# MISSISSIPPI POWER & LIGHT COMPANY

SUBJECT: Grand Gulf Nuclear Station  
Units 1 and 2  
Docket Nos. 50-416 and 50-417  
License No. NPF-13  
File: 0260/L-860.0  
Additional Information - TDI Engine  
Inspection  
AECM-84/0373

Following the NRC review of the Mississippi Power & Light TDI engine inspection results, the need for additional information and actions was identified. A request for additional information was transmitted July 17, 1984, in the NRC letter from E. G. Adensam to L. F. Dale. Enclosed are descriptions of MP&L actions and documentation of additional information in response to this request.

TABLE 1  
Cylinder Head Baseline  
Data for Flatness

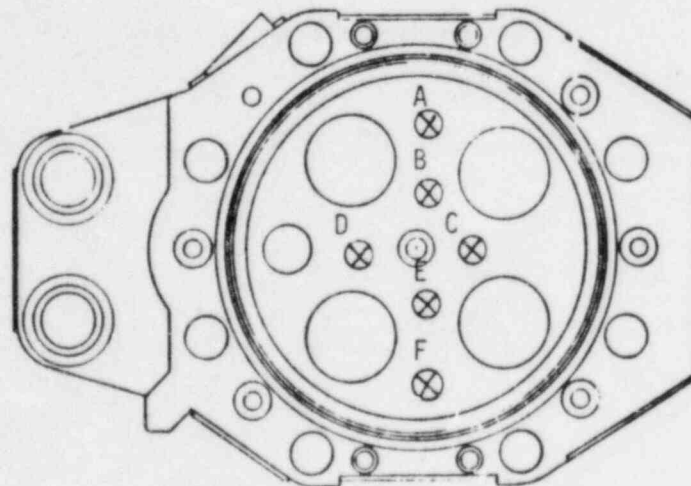
4. Documented results of measurements of the cylinder head fire deck surface flatness.

A straight edge and micrometer were utilized to obtain baseline information for the cylinder head fire deck profiles. Measurements were taken at six different locations on the fire deck. Readings varied from head to head as to the depth of the fire deck depression. Results of the measurements are shown in TABLE 1.

Changes in readings taken across the fire deck were due to the curvature of the fire deck and were consistent for all heads and did not indicate a problem with head warpage. These readings were taken for baseline data to be used in the future to determine if warpage of the heads may have occurred.
